Sky International Inc.

SERVICE LETTER NO. 3

**Kits available for the Husky A-1B Increased Gross Weight to 2200Lbs.
with additional propellers**

DATE: 11 June 2008
REVISION: B

Figure 4.2-1 New 5-Leaf Tail Wheel Spring

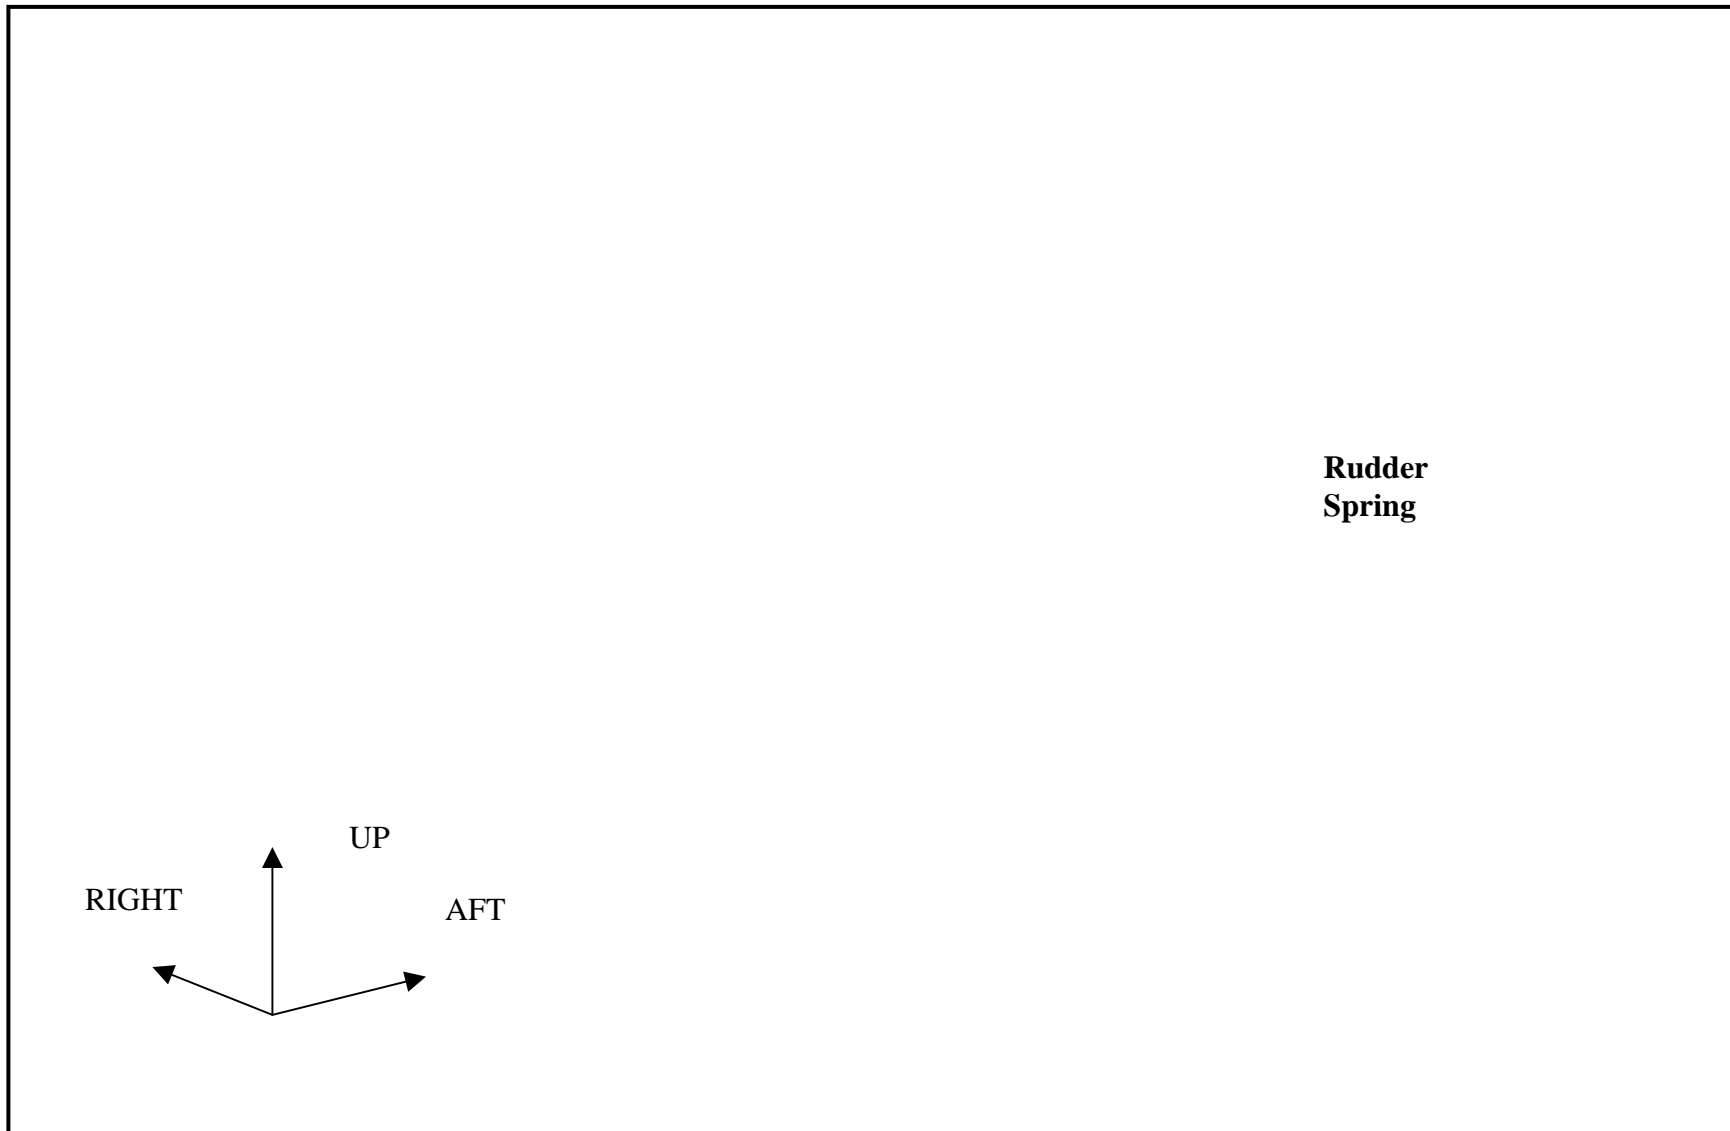
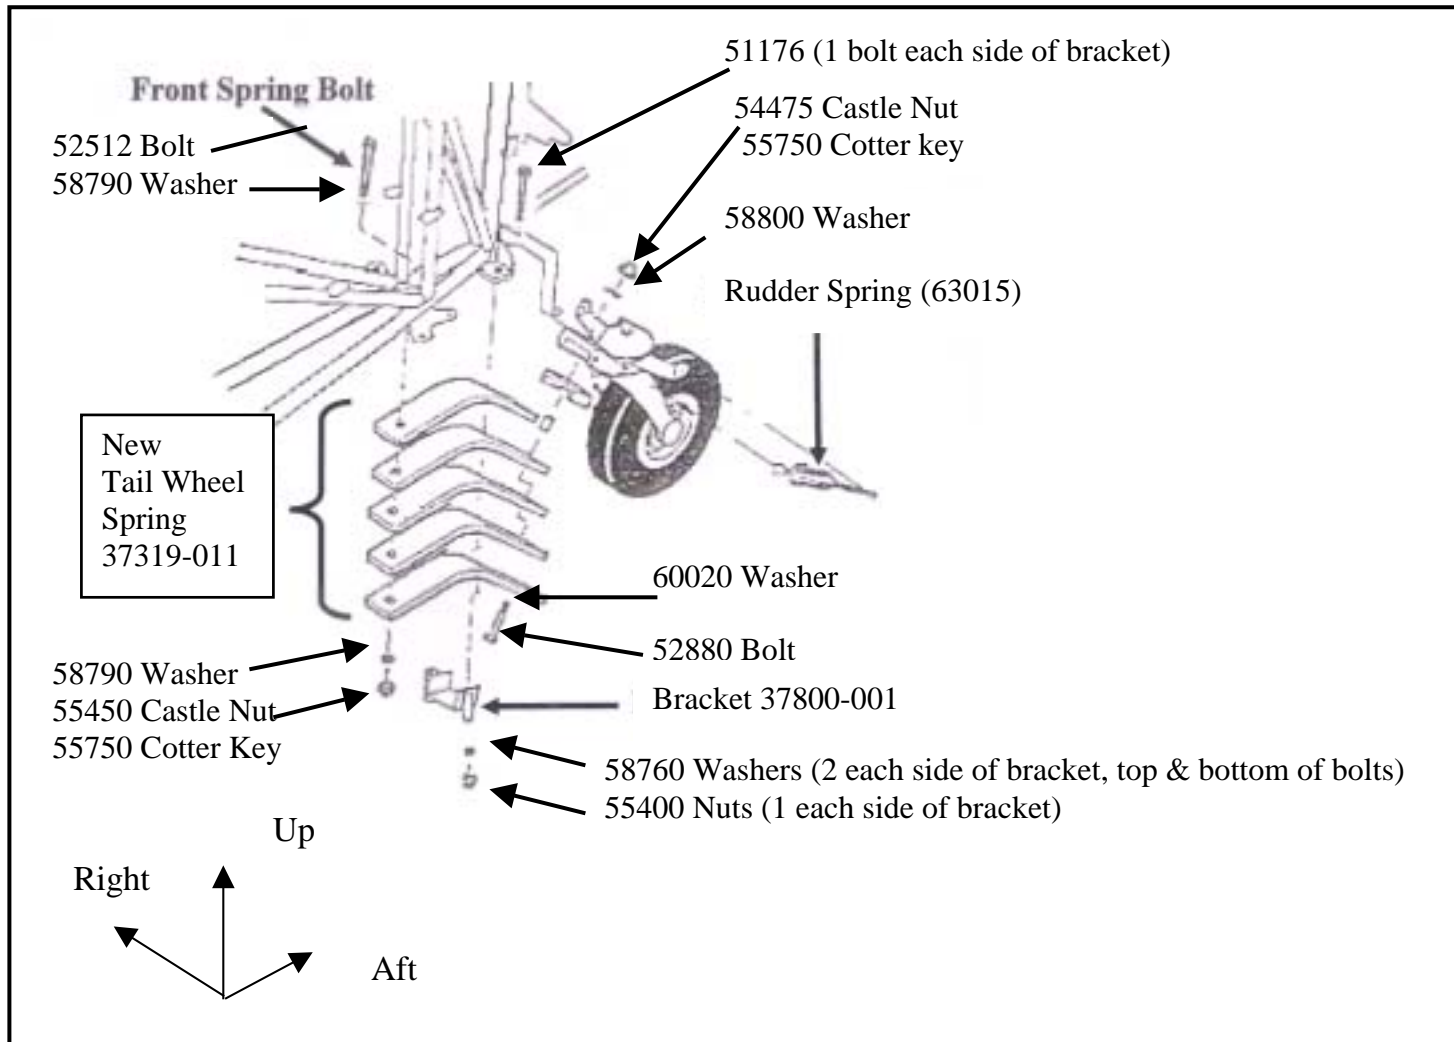
- New horizontal stabilizer support tube
- New main landing gear
- New 5 leaf tail wheel spring

4.1 Removal of Old Tail Wheel Spring

1. Attach the new tail wheel spring (part number 37319-011) to the fuselage by installing washer (58790) under head of bolt (52512). Insert bolt and washer (bolt direction is down refer to figure 4-1.2) thru hole in covered fuselage to be inserted thru butterfly bracket and front bolt hole of tail wheel spring. Install washer (58790) onto bolt and then castle nut (55450). Do not fully tighten the bolt. Tighten it only enough to keep the tail wheel spring in place.

2. Loosely attach the tail spring bracket (37800-001) connecting the bottom of the tail spring to the rear of the fuselage. Install washers (58760) on bolt heads (51176 one on each side of bracket) Insert bolts up thru bracket and thru plate on fuselage. Install washers (58760) on bolt on each side) and then nuts (55400). Do not tighten all the way.

3. Attach the tail wheel assembly to the tail wheel spring. Install washer (60020) under head of bolt (52880). Insert bolt and washer through rear hole of tail spring, tail wheel spacer, tail wheel bracket and through tail wheel assembly. Bolt direction is up. (Refer to illustration 4-1.2) Put washer (58800) and nut (54475) onto bolt and attach loosely. Do not tighten all the way.

Figure 4.4-1 New Main Landing Gear

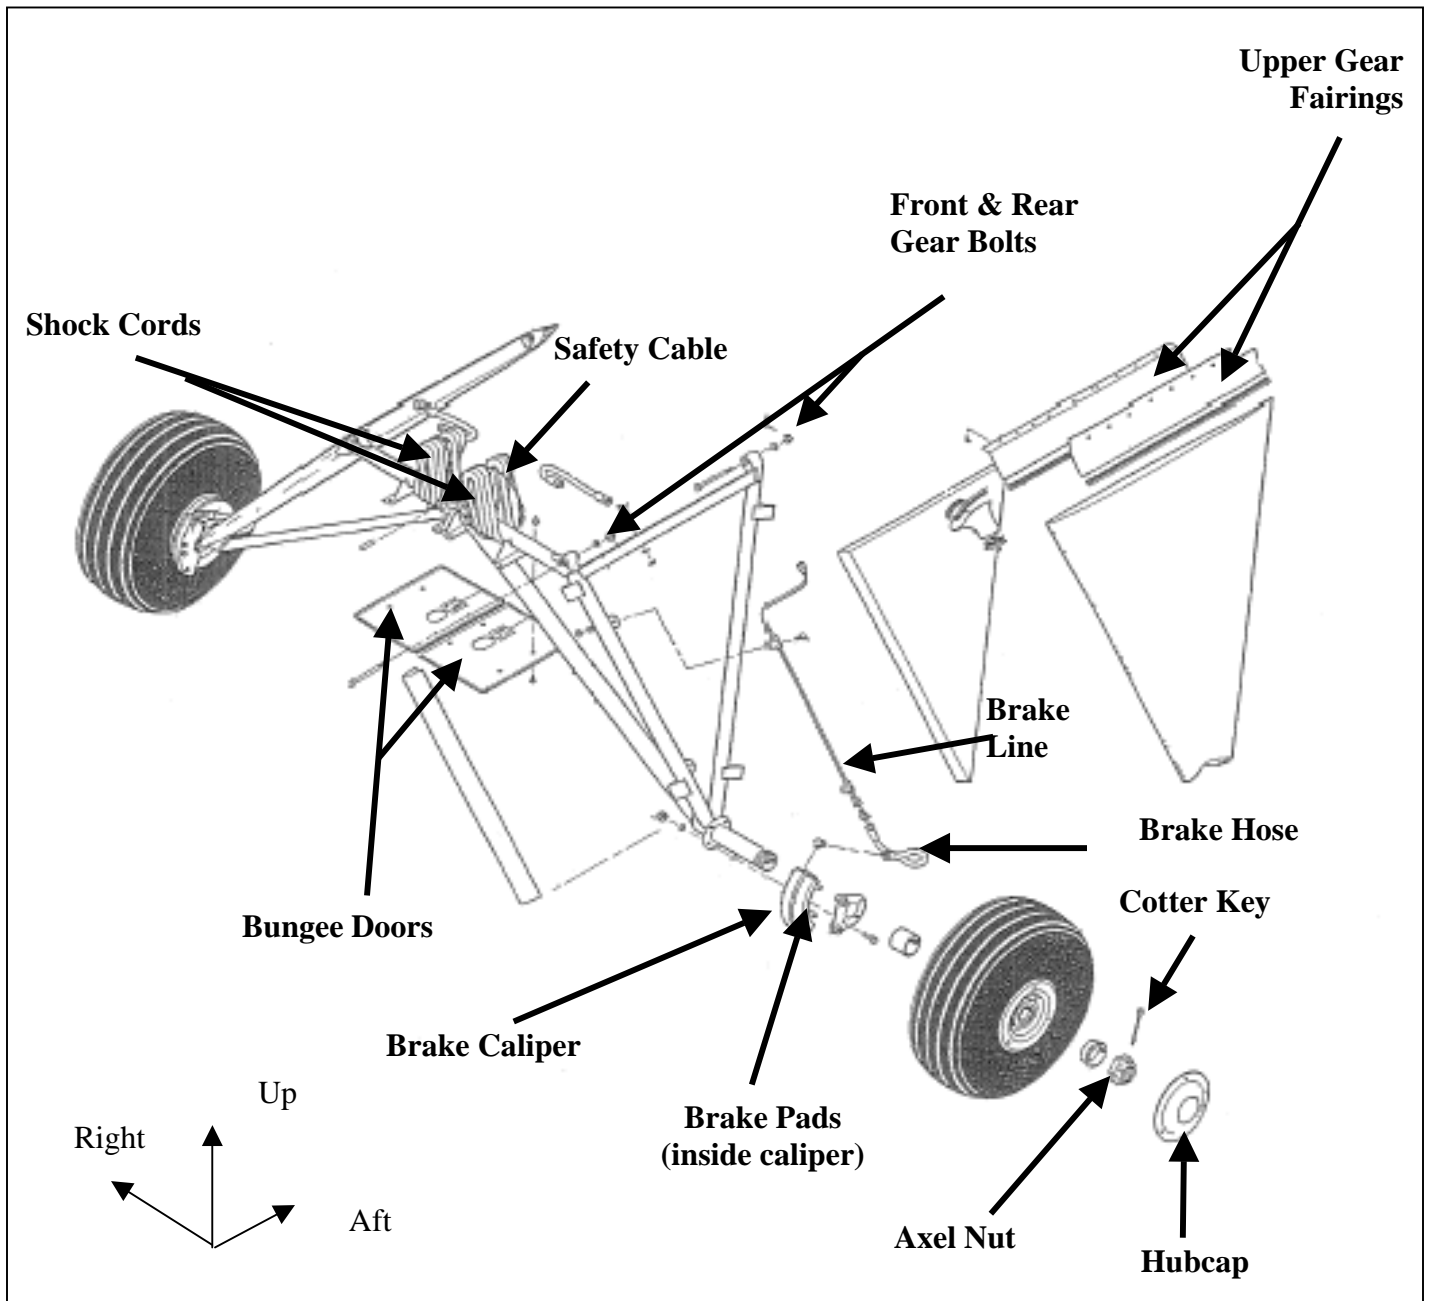
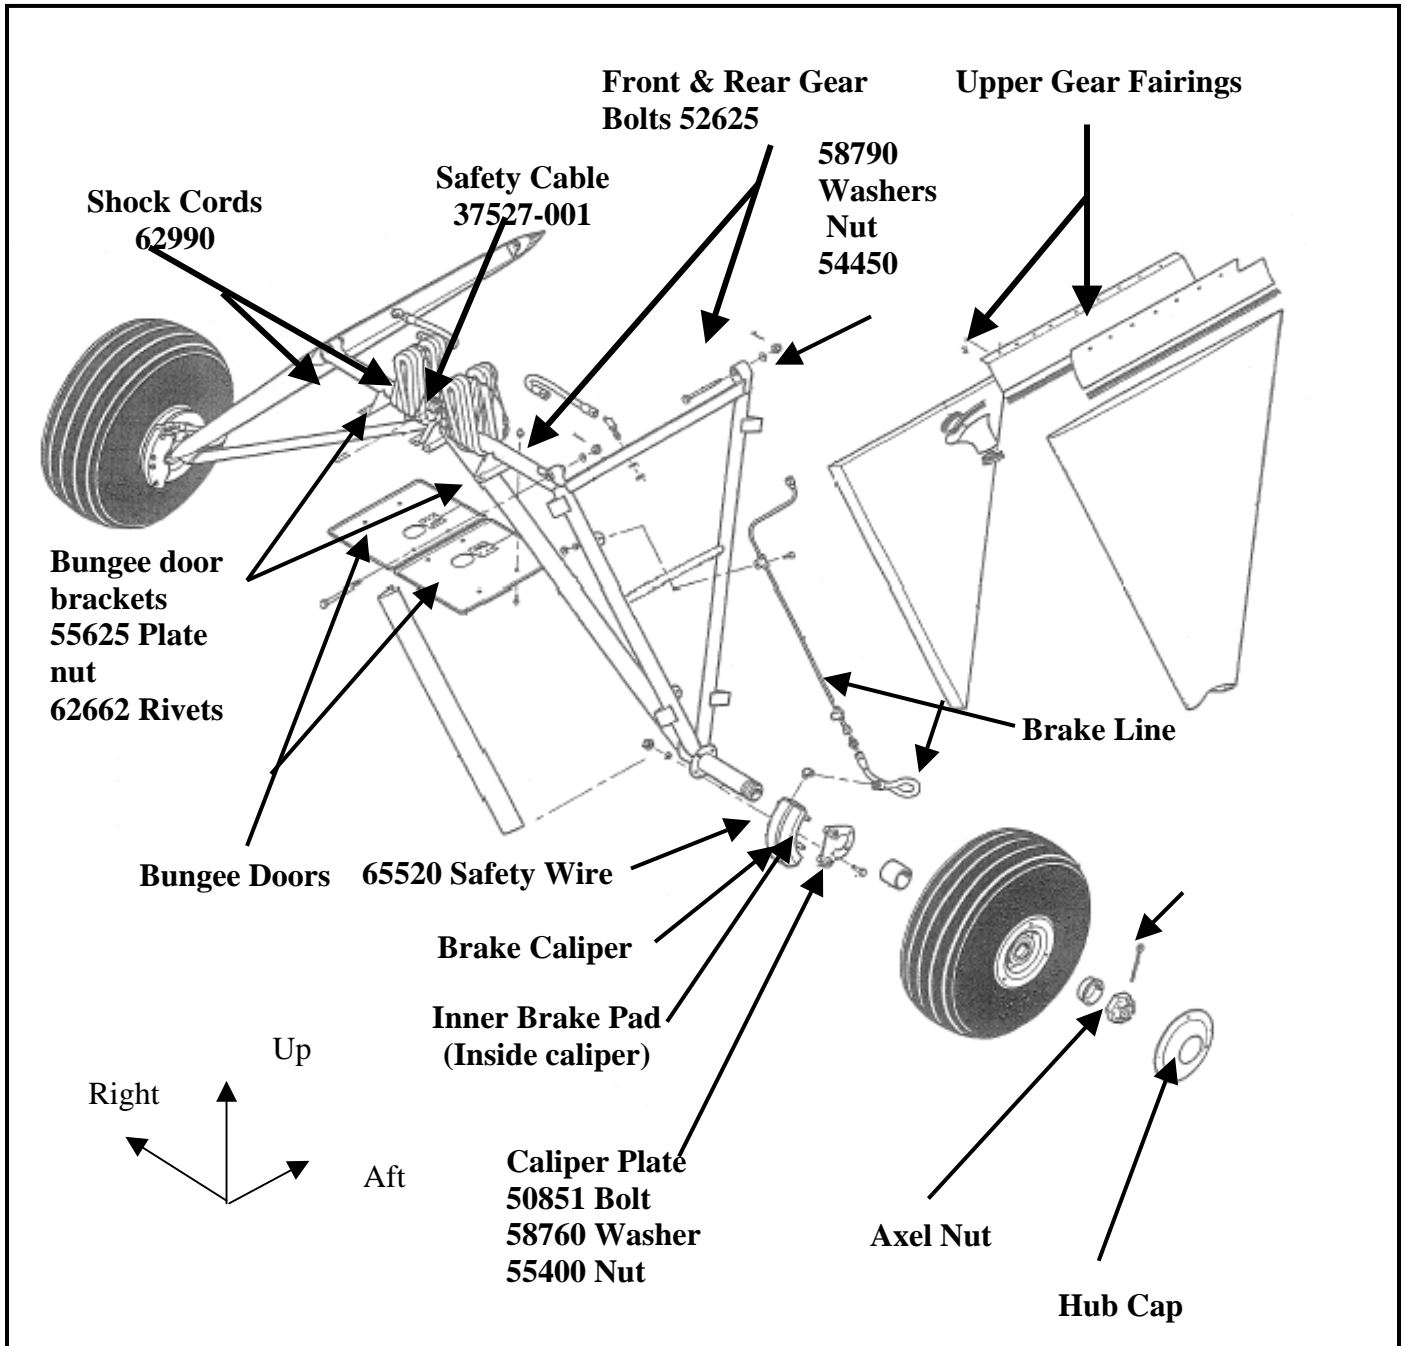
4.3 Removal of Old Main Landing Gear

1. Attach the bumper block to the gear using 2 wires (part number 1-0231-026).
2. Reinstall brake line and fittings.
3. Reinstall front reinforcement edge with duct tape.

4. Drill and countersink for installation of plate nuts (part number 55625) with pop rivets (part number 62662) on bungee door brackets on gear.
5. Attach the front and rear gear bolts (part number 52625) and nuts (part number 54450) and install the new landing gear (part numbers 45017-501 and 45017-502). Washer bolts as needed (part number 58790).

6. Install new safety cable (part number 37527-001) with Nico presses (part number 62272) (2 per cable). Leave ¼ inch of cable protruding past nico press also leave ¼ inch of cable between nico presses.

Figure 4.6-2 Horizontal Stabilizer Support Tube Location

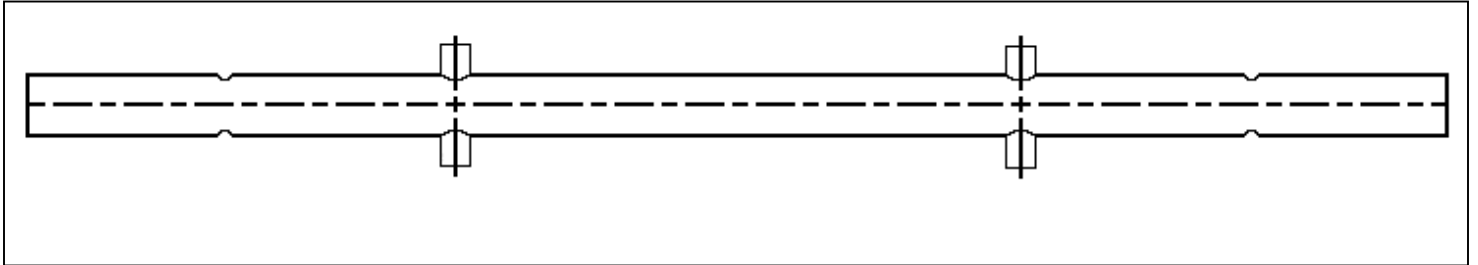
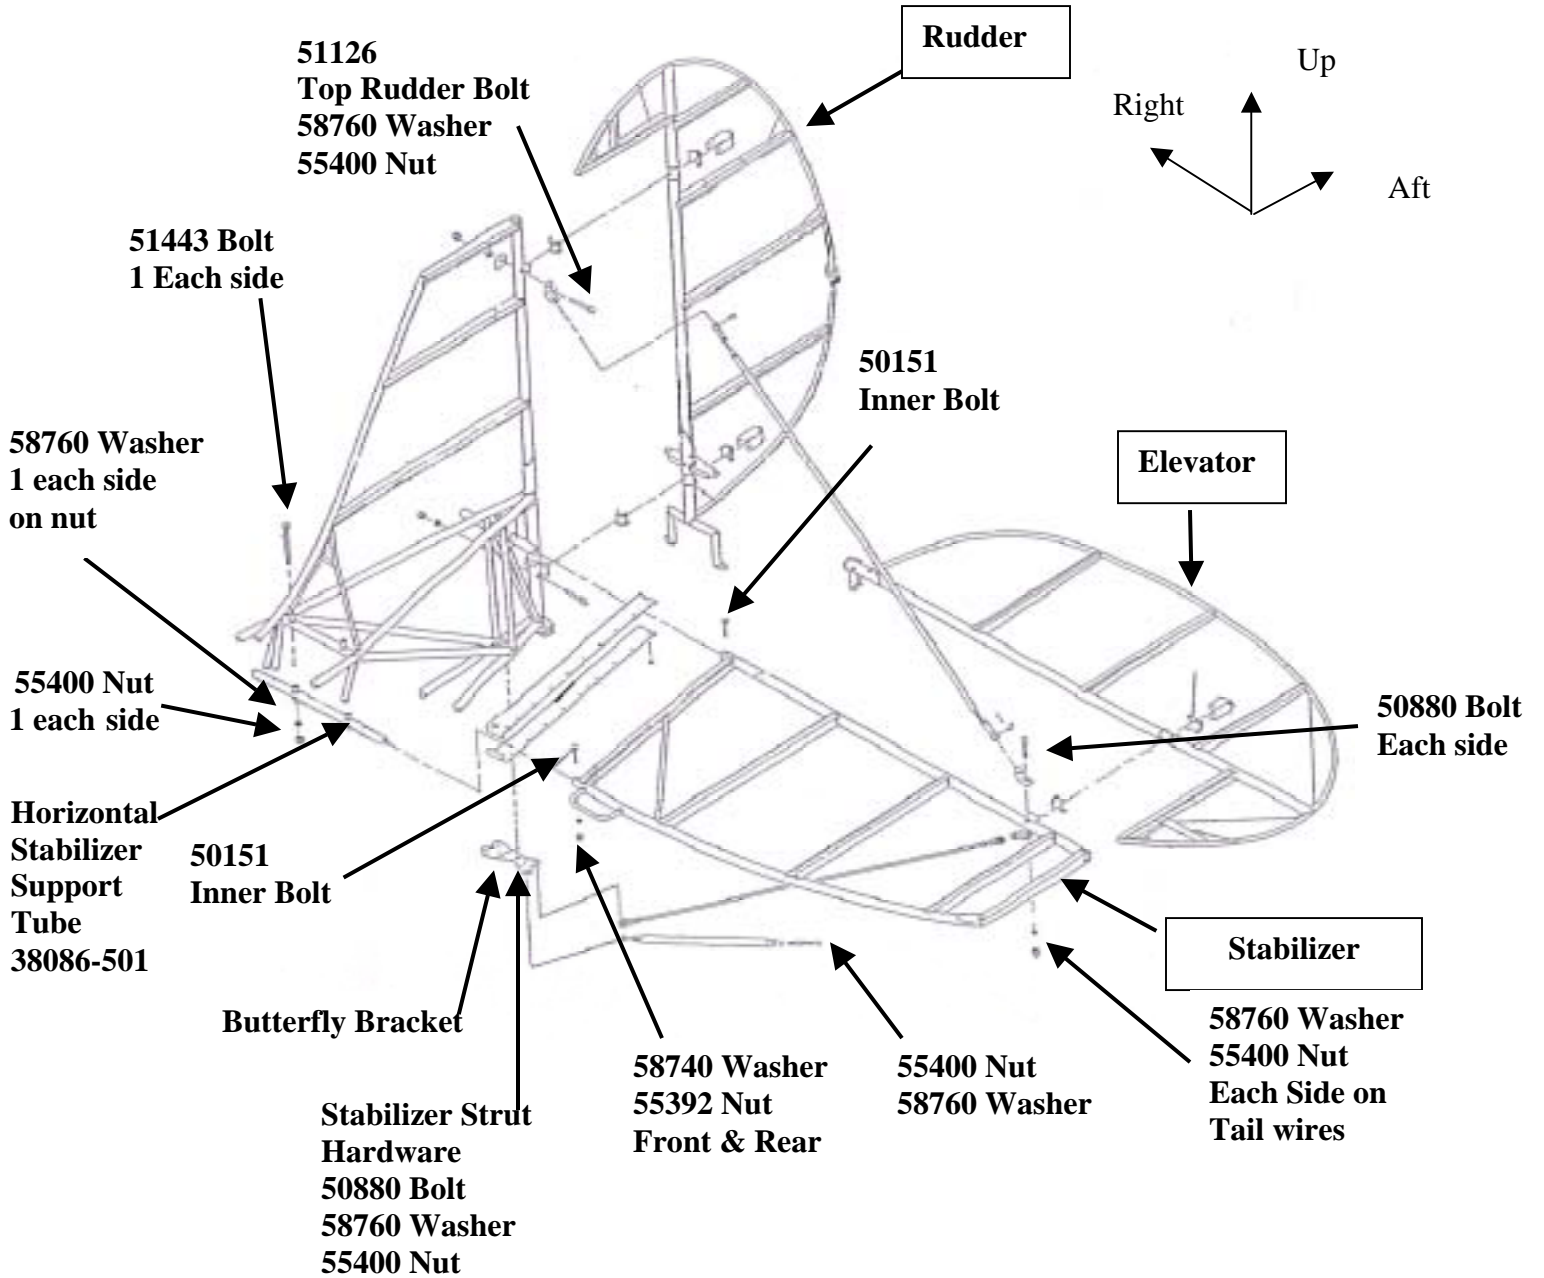
4.5 Removal of Old Horizontal Stabilizer Support (See also Figure 4.6-2)

1. Slide the new stabilizer support (part number 38086-501) through the hole-cover openings. Be very careful not to tear the fabric any more than necessary.

2. Use 2 people to attach the stabilizer support (one person on each side of the plane). Have one person hold the stabilizer support while the other screws on the nut (part number 55400) to the bolt (part number 51443). Washers (part number 58760) are placed under bolt and on nut on each side. Repeat for the bolt on the opposite side. Tighten hardware.

10. Check the tail wire tensions to make sure they are between 100 and 125 lbs.
11. Install hole covers with PK screws (part number 59105). Align screw holes and screws horizontally with fuselage.
